**TOWN OF NEWBURGH  
PLANNING BOARD  
TECHNICAL REVIEW COMMENTS**

**PROJECT NAME:** 7 GRIMM ROAD – TWO FAMILY  
**PROJECT NO.:** 25-33  
**PROJECT LOCATION:** SECTION 76, BLOCK 5, LOT 9  
**REVIEW DATE:** 25 NOVEMBER 2025  
**MEETING DATE:** 4 DECEMBER 2025  
**PROJECT REPRESENTATIVE:** A. HENNESSY ARCHITECTS

**1 SITE PLAN**  
SCALE: 1" = 10'-0"

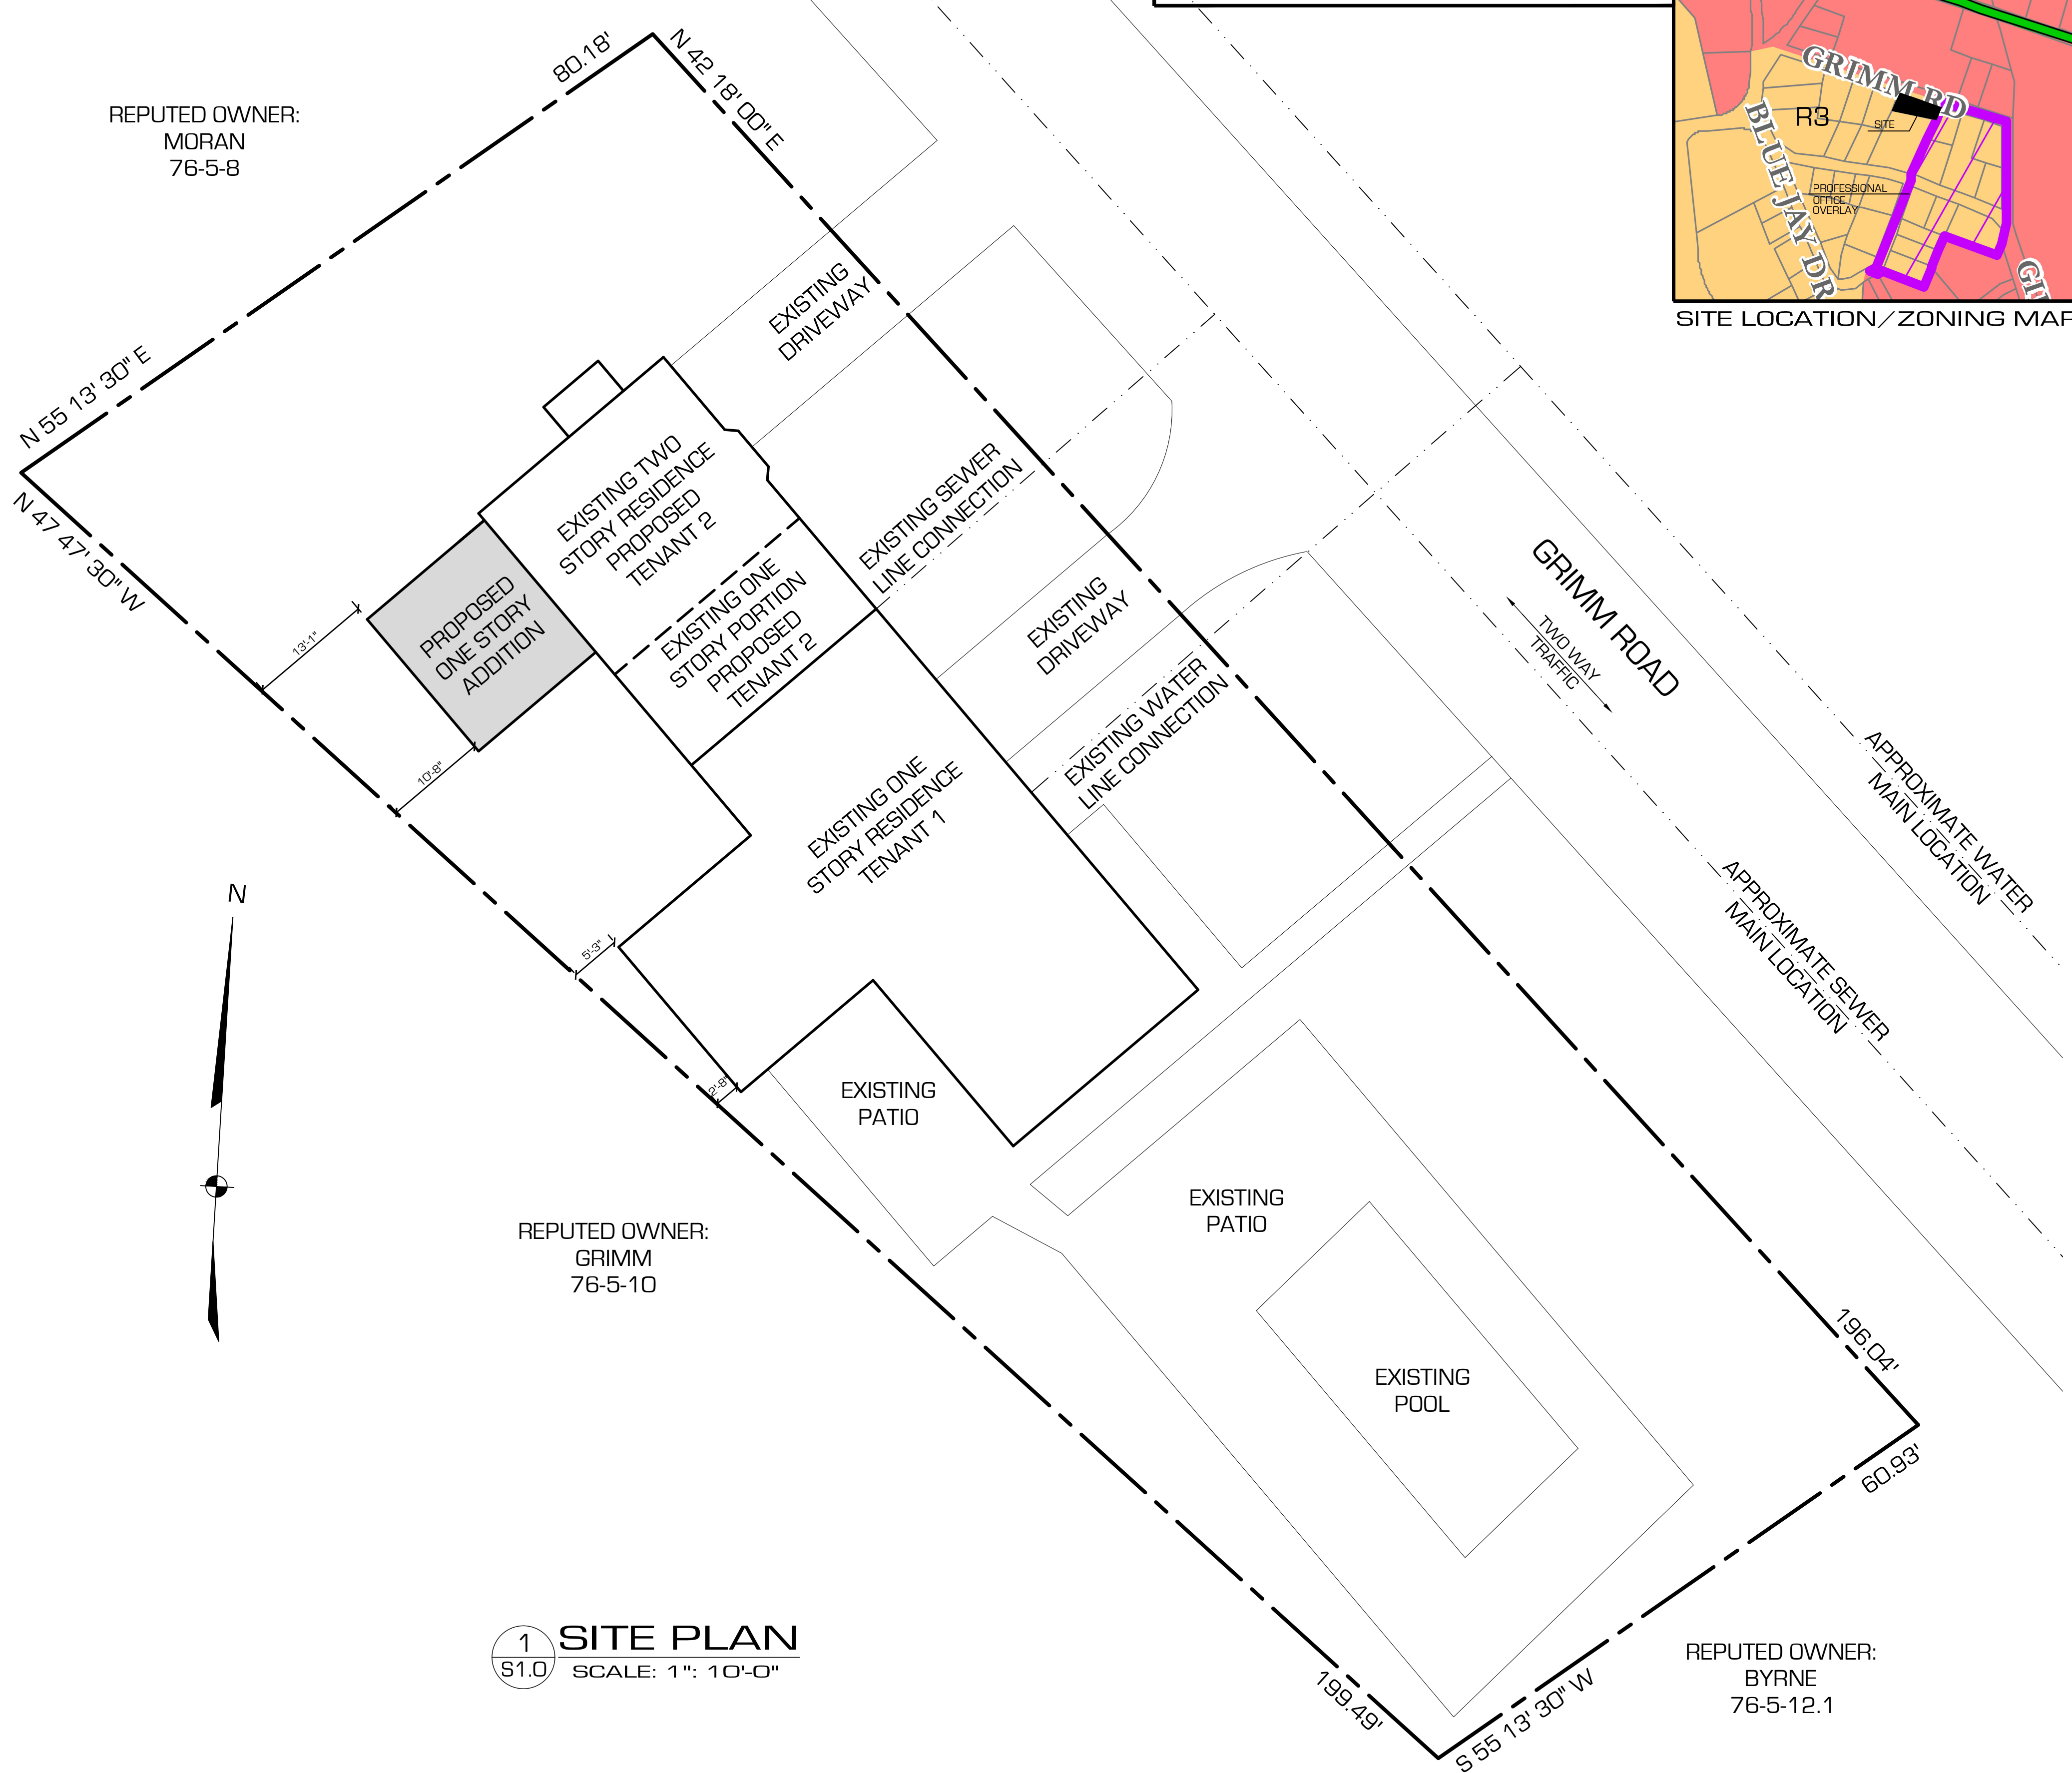
1. The project proposes a two-family residence in the R3 Zoning District. The proposed project requires numerous variances including the following:
  - Lot area 100,000 square feet required, 13,712 square feet provided.
  - Lot width 200 feet required, 196.04 provided.
  - Lot depth 130 feet where 80.18 feet is provided.
  - Front yard setback 50 feet required where 22.9 is provided.
  - Rear yard 50 feet where 2.9 feet is provided.
  - Side yard one side 30 required where 25.3 is provided.
  - Lot surface coverage 40% maximum where 45% is proposed.
2. In the bulk table the lot building coverage should specifically be identified, 20% is maximum where 20% is identified as provided.
3. The applicant’s representative asked to discuss whether individual water and sewer service will be provided to the proposed tenant two occupancy.
4. Adjoiners Notices must be circulated per Town Code.
